SEQUOYAH - UNIT 2

PROPOSED TECHNICAL SPECIFICATION CHANGE

(TVA-SQN-TS-87-46)

DESCRIPTION AND JUSTIFICATION FOR
THE REVISION OF TABLE 3.6-1,
"BYPASS LEAKAGE PATHS TO THE
AUXILIARY BUILDING"

HYDROGEN ANALYZER SYSTEM SCHEMATIC (EXISTING CONFIGURATION FOR TRAIN A)

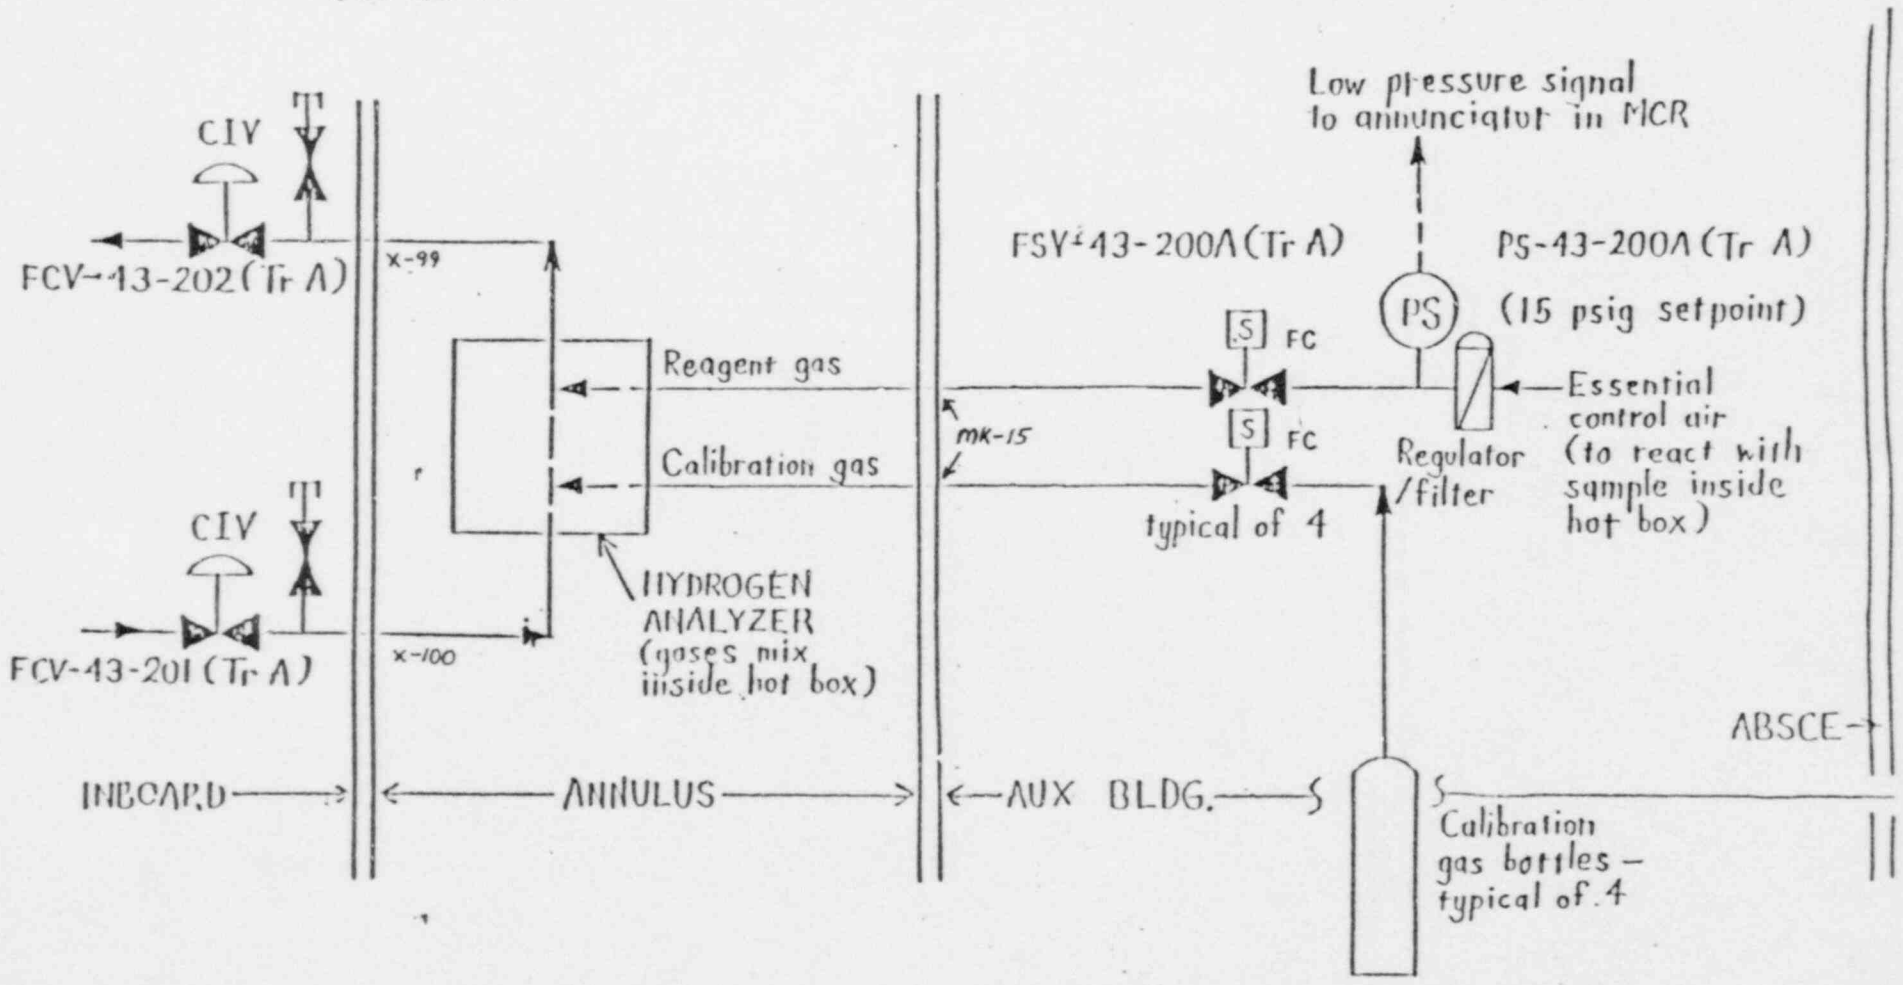
Figures 1 and 2 show the Train A and B hydrogen analyzer system configurations that contained the potential bypass leakage path to the environment. After a postulated LOCA, the inboard containment isolation

valves (CIVs) would have been open because they were fail-open air-operated valves, and the control air would have been isolated during the accident. If the hydrogen analyzer was in the "analyze" mode, the electrically operated solenoid valve on the reagent-gas line would have been open as designed. If the failure of one train of essential control air was also postulated, the pressure in the control air line (reagent gas) supplying the hydrogen analyzer could have fallen below containment pressure, allowing the potential bypass leakage to the environment through the essential control air system. The train B analyzer also contained additional potential bypass leakage paths to the environment because some of its components were located outside the ABSCE.

HYDROGEN ANALYZER SYSTEM SCHEMATIC (CHANGES FOR TRAIN A)

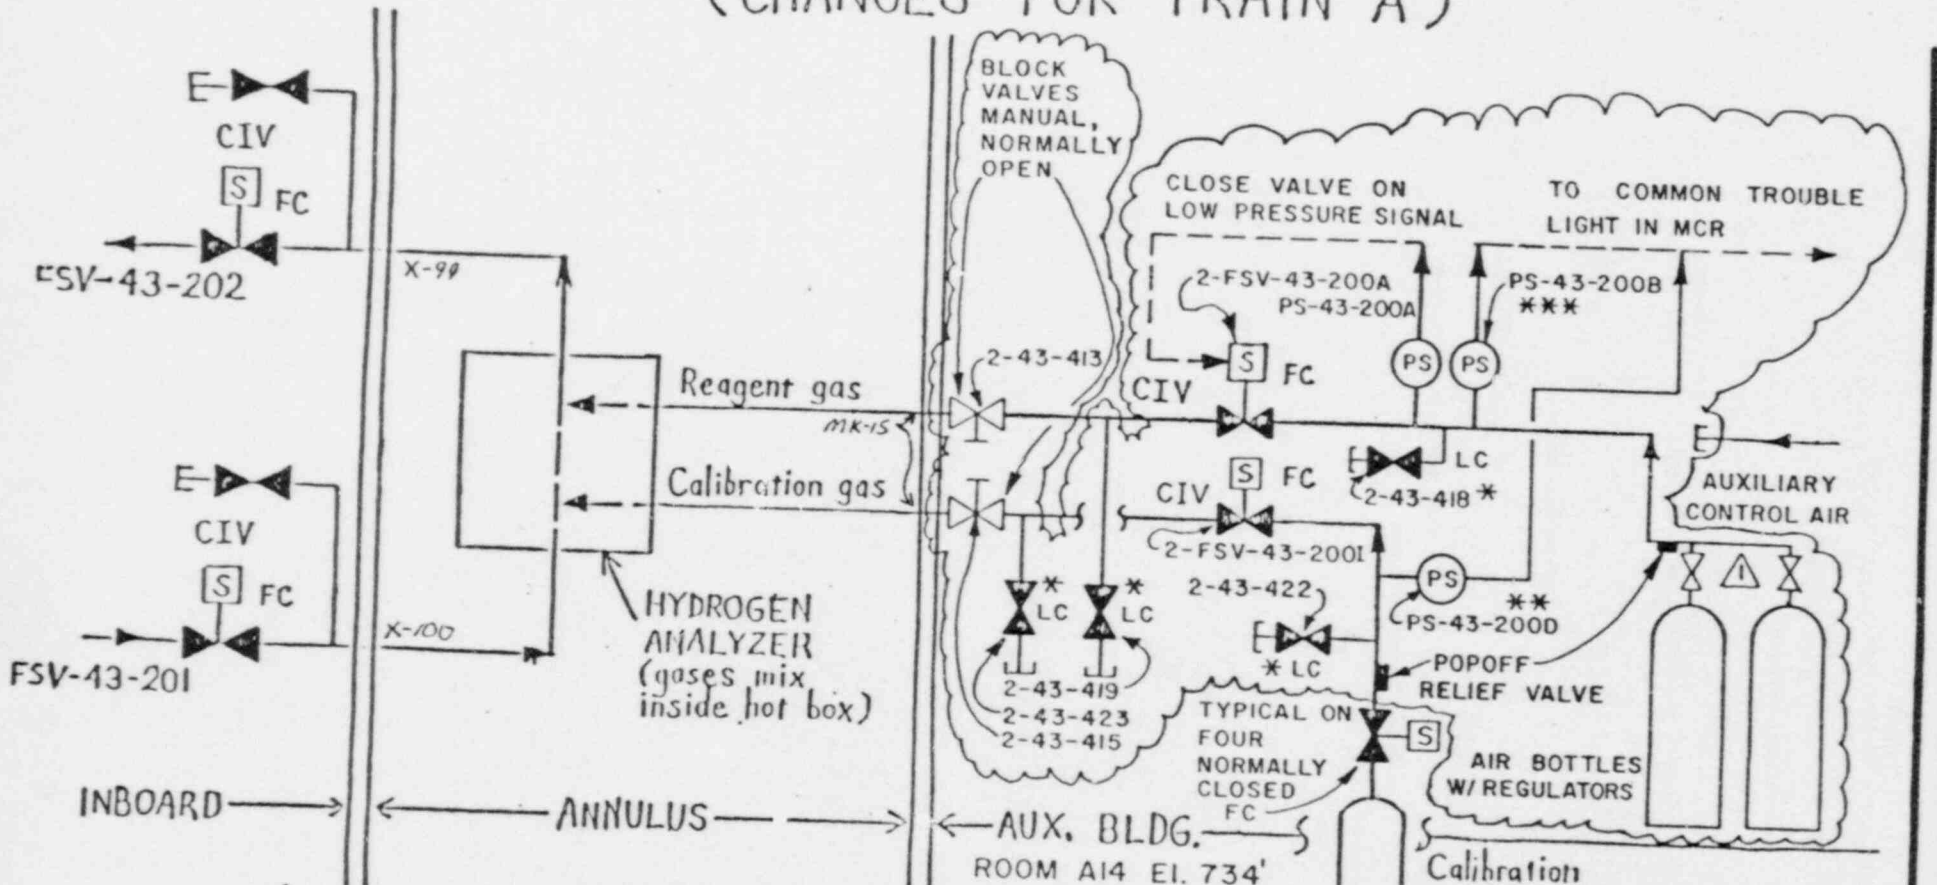
⚠ ADMINISTRATIVE MEASURES TO BE TAKEN TO ENSURE CONSTANT PRESSURE TO PANEL

* TEST CONNECTIONS

** REPIPED FROM ZERO GAS BOTTLE LINE DOWNSTREAM OF WHERE 4 CAL GAS BOTTLES TEE

*** REPIPED FROM 8% (SPAN) BOTTLE TO REAGENT GAS LINE (ITEMS WITH BUBBLE TO BE ADDED)

Figures 3 and 4 show the modified hydrogen analyzer system configurations for trains A and B. ECN 7332 replaced the inboard CIVs with electrically operated fail-closed solenoid valves. The valves are TVA class B, qualified to operate in a harsh environment for 30 days, and leak tested in accordance with existing procedures.

ECN 7333 modifies the portion of the hydrogen analyzer system located in the Auxiliary Building to eliminate potential bypass leakage paths to the environment. For both trains, the analyzer will be disconnected from the essential control air system. Bottled air will be used as the reagent-gas supply. All bottles used for this function will have documentation to show class B equivalence.

Also, the reagent-gas pressure switch will be reconfigured for both trains to provide automatic closure of the reagent-gas solenoid valve on a low-pressure signal. This ensures that the potential leakage path is isolated with sufficient line pressure remaining to prevent outleakage through the reagent-gas solenoid valve. Because these components are located in a seismically qualified structure and the pipe is equivalent to class B, failure of the piping between the solenoid valve and the bottled air source is not considered credible.

For the train A analyzer, the solenoid valves on the lines for reagent and calibration gas are designated as CIVs and tested accordingly. These valves do not require a gas seal on the outboard side because the valves are located within the ABSCE boundary; and any leakage would be processed by the Auxiliary Building Gas Treatment System (ABGTS). However, to ensure an adequate supply of reagent gas to the train A analyzer, similar administrative controls will be used for transferring supply bottles to the analyzer.

Test connections are added to both trains as shown in the figures for the testing of the CIVs. Test connection valves between the CIVs will be class B. They will be normally locked closed and added to the appropriate plant procedures for tracking locked closed test connections. Test connections outside the CIVs do not form part of the containment isolation pressure boundary. These outer test connection valves will also be locked closed to ensure the system seal.

HYDROGEN ANALYZER SYSTEM SCHEMATIC (CHANGES FOR TRAIN B)

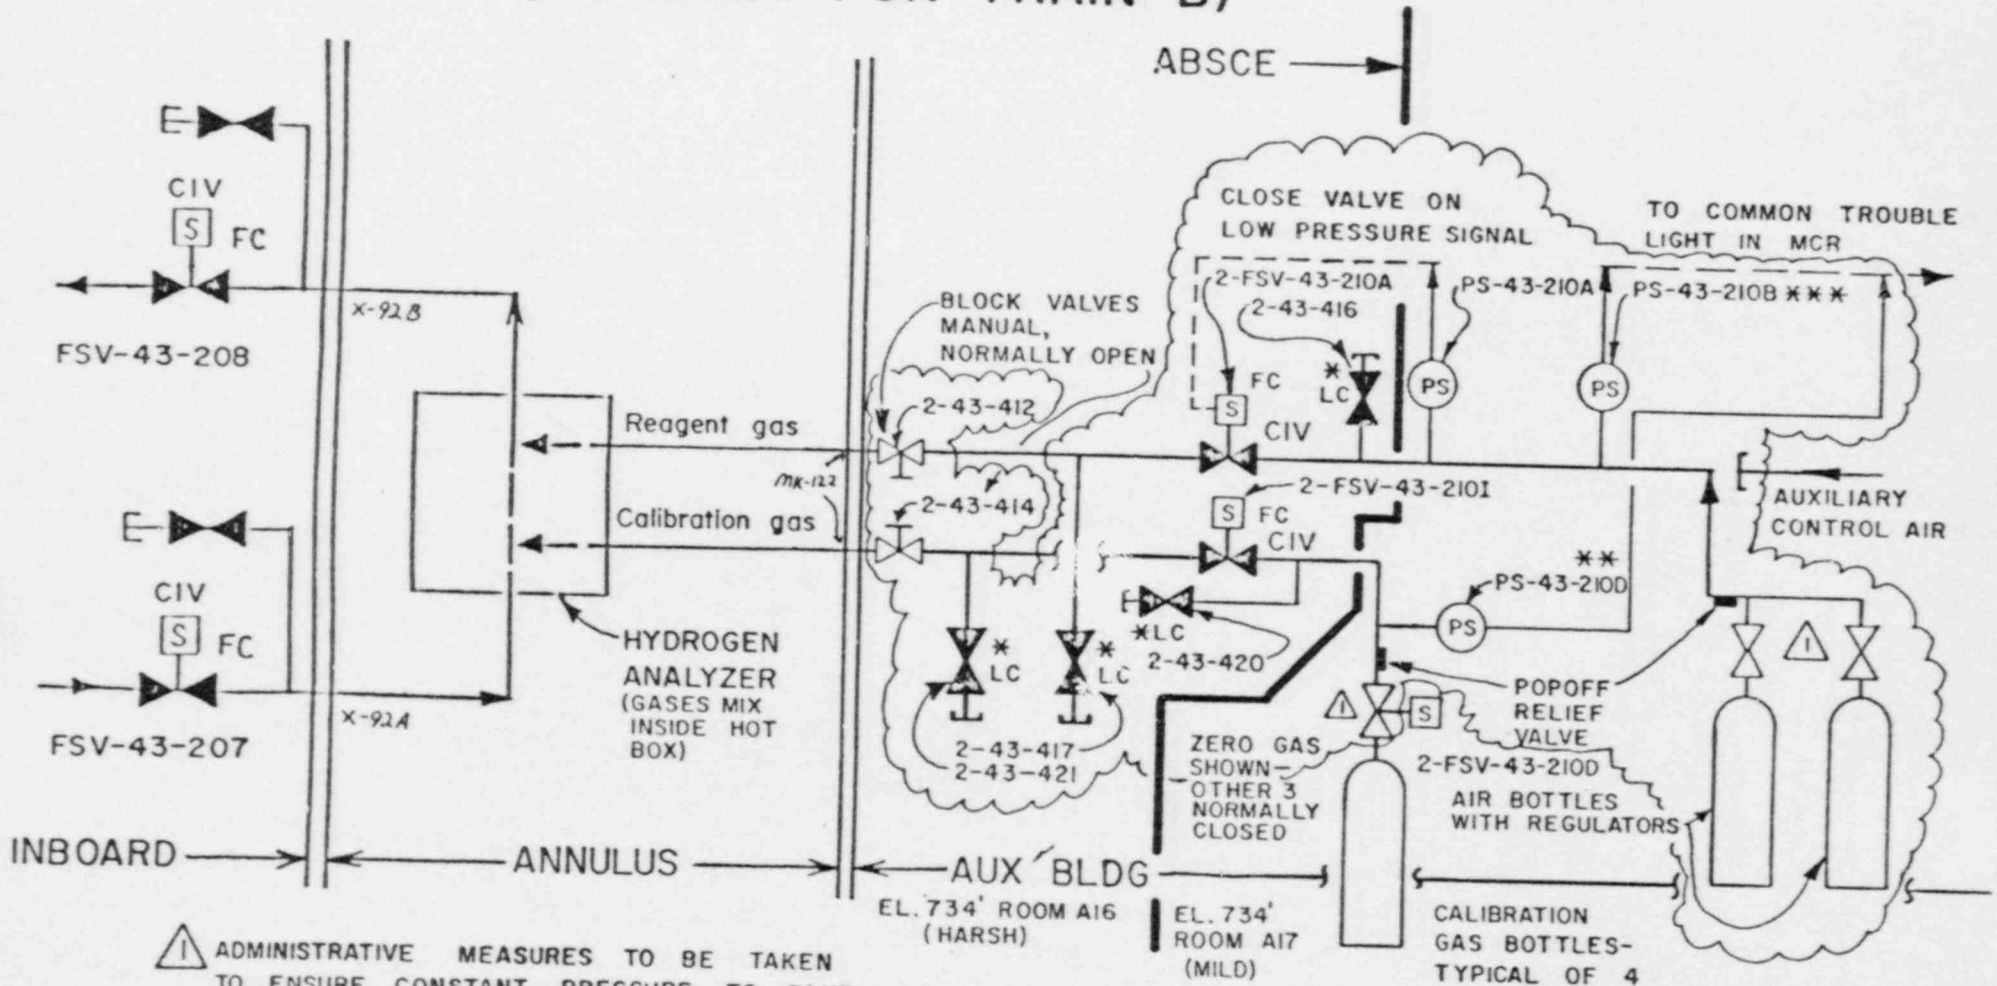
- ⚠ ADMINISTRATIVE MEASURES TO BE TAKEN TO ENSURE CONSTANT PRESSURE TO PANEL
- * TEST CONNECTIONS
- ** REPIPED FROM ZERO GAS BOTTLE LINE DOWNSTREAM OF WHERE 4 CAL GAS BOTTLES TEE
- *** REPIPED FROM 8% (SPAN) BOTTLE TO REAGENT GAS LINE

(ITEMS WITHIN BUBBLE TO BE ADDED)

Additionally, for the train B analyzer, the reagent-gas solenoid valve is relocated to inside the ABSCE boundary. This valve will meet the intent of class B. This valve is normally closed, but is opened during analyzer calibration and operation. This valve will be designated as an outboard CIV and tested as such in the appropriate procedures. Administrative controls will be used to ensure that sufficient gas pressure is available to prevent outleakage through the train B calibration-gas CIV. These controls will also ensure an adequate reagent-gas volume is available for the operation of the analyzers after an accident. The administrative controls will rely on procedural operator inspections and manual transfer of supply bottles. Transfer of the supply bottles will not result in a loss of gas pressure because of the use of a supply manifold with multiple isolatable bottles.

A solenoid valve is also added to the line for train B calibration gas. It too will be inside the ABSCE boundary. The valve will meet the intent of TVA class B. This valve is normally closed, but will be opened during calibration of the analyzer. This valve is also designated as an outboard CIV and tested accordingly. To ensure that a proper gas seal is available for this valve, the zero gas solenoid valve will be changed to a normally open, fail-open valve. Administrative controls will again be used to ensure sufficient gas pressure is available to prevent outleakage through the calibration-gas CIV.
